Report by the Mining and Petroleum Gateway Panel  
to accompany a Conditional Gateway Certificate  
for the Narrabri Underground Mine Stage 3  
Extension Project

4 June 2019

**Figure 3.** Location of verified BSAL in GCAA and location of test pit sites. NB the area of potential BSAL in the GCAA not confirmed due to access limitations (NCOPL 2019).

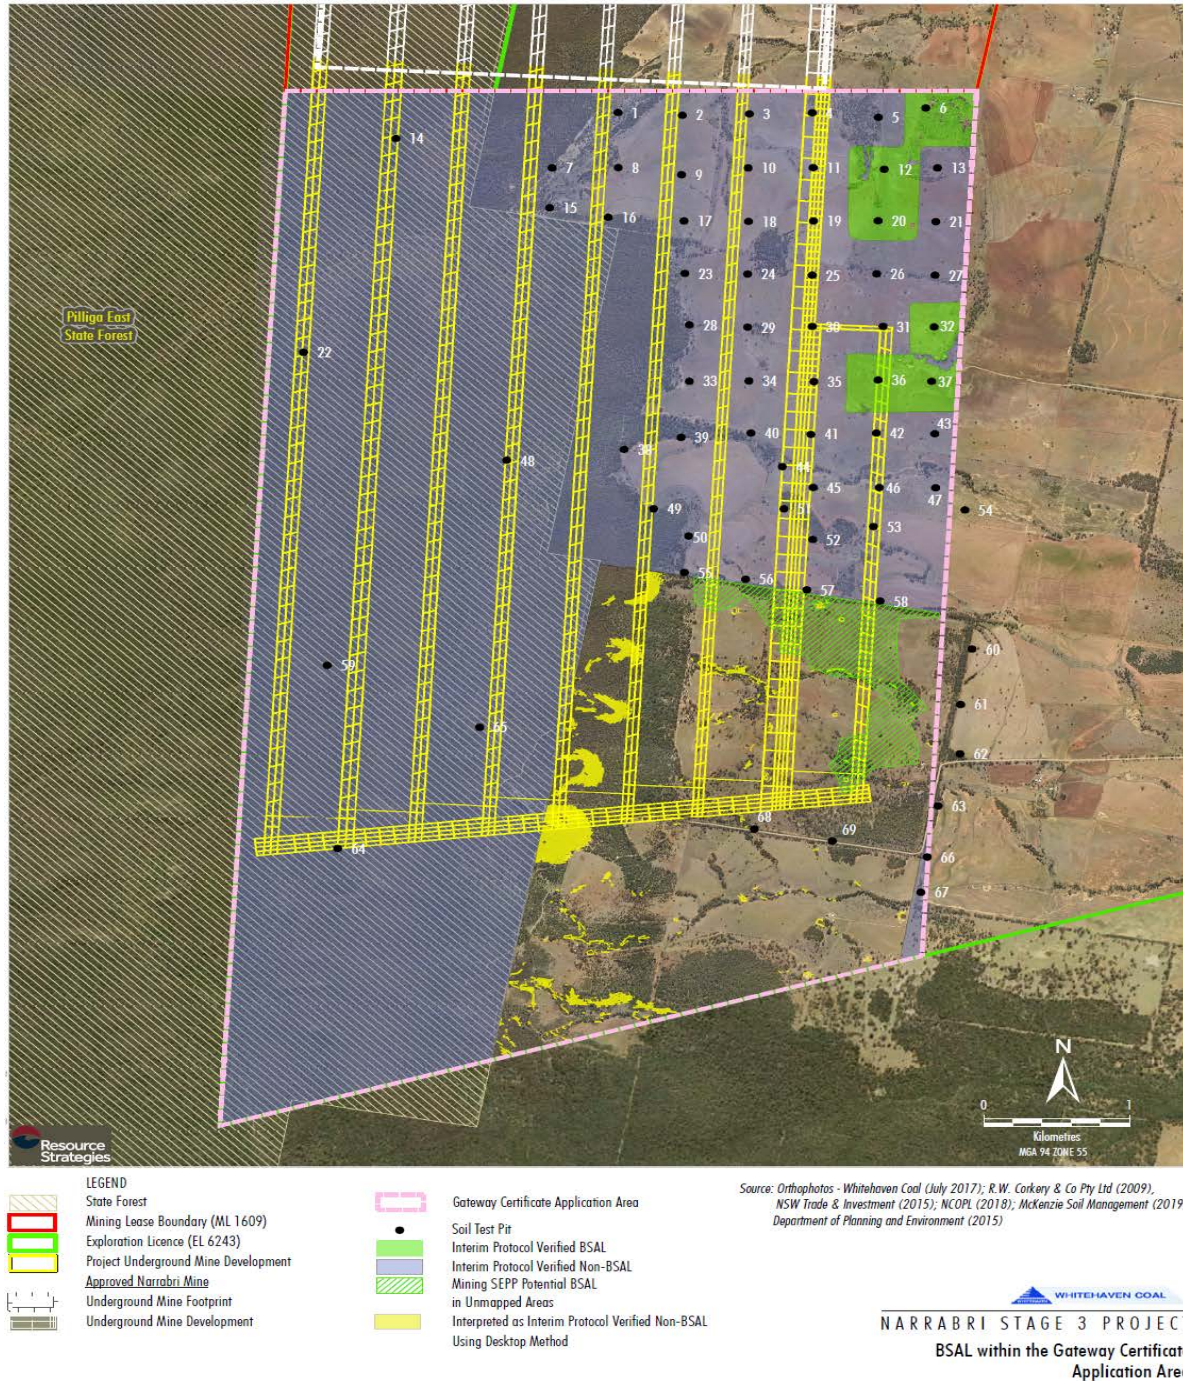
While not verified due to access limitations, an additional 95 ha of potential BSAL is located on land within the GCAA. Of this potential BSAL approximately 60 ha is present above the area to be affected by longwall mining. It is imperative that the status of this potential BSAL be determined as soon as practicable.

Figure 4. Conceptual Groundwater Flow Model (from HydroSimulations, 2019).

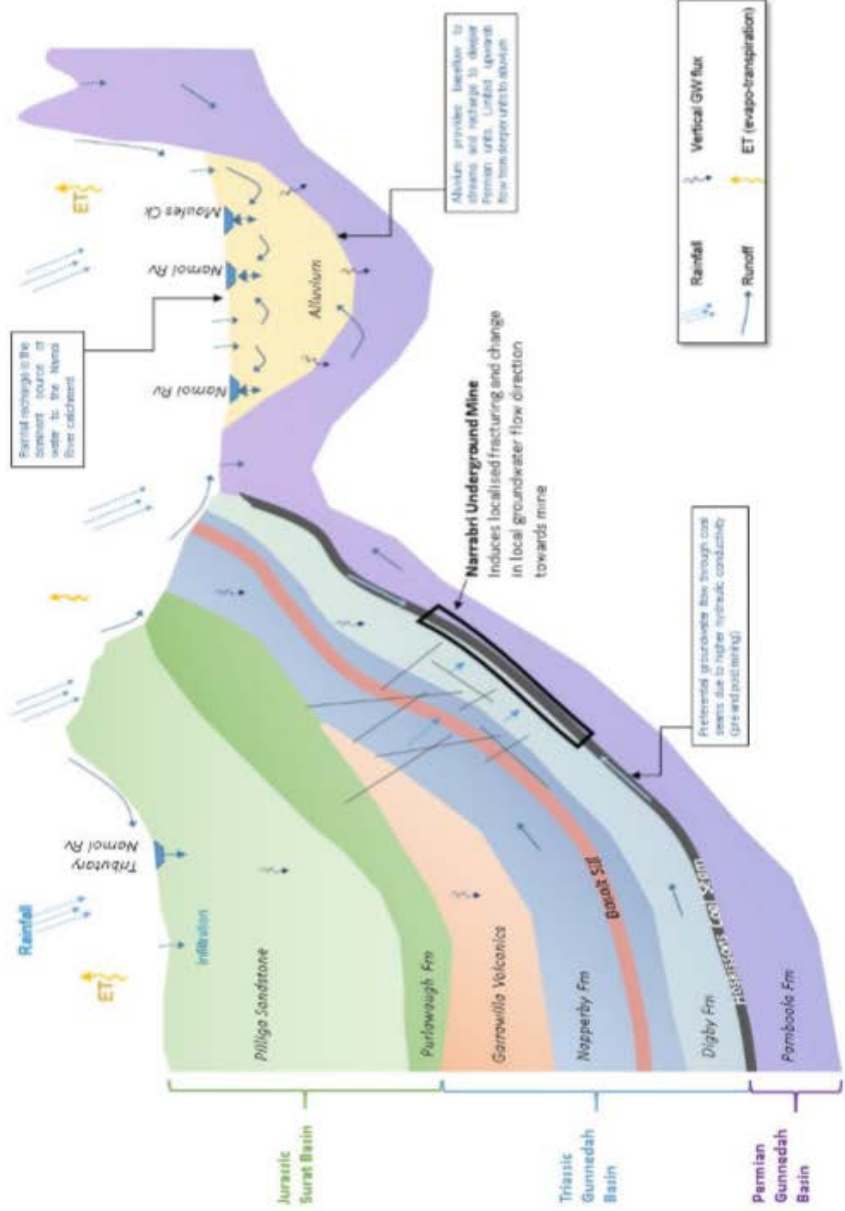
The Panel considers the conceptualization of the regional geology and hydrogeology to be plausible and adequate at this early stage of assessment and that the processes of groundwater flow from one water source to another have been identified at a broad scale. At a local scale there are still uncertainties such as the extent to which fracturing, caused by mine subsidence, will modify groundwater flow and also the impacts of faults and a basalt intrusion on flow.
